TECH TIP #2003-01

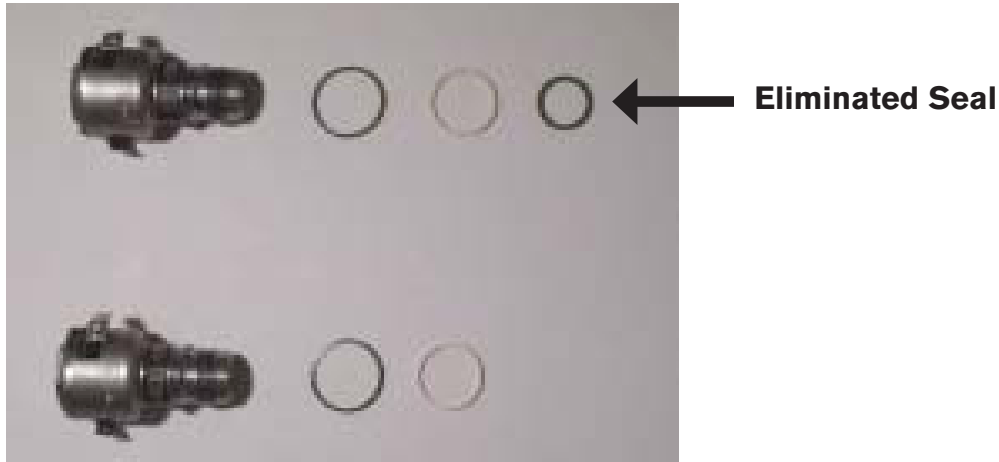
You may notice that your Jake Brake® engine brakes looks a little different. Discarding the lower seal is the answer to insure the solenoid will work in any Jake Brake engine brake application.

Shown below are the old and new style engine brake housing photos showing the differences. If you have an old style housing, you may still discard the lower solenoid seal. Either way, the *same solenoid (along with the upper and middle seals)* work in both old and new housings. The newer housings are not machined to accept the fit of the solenoid's lower seal.
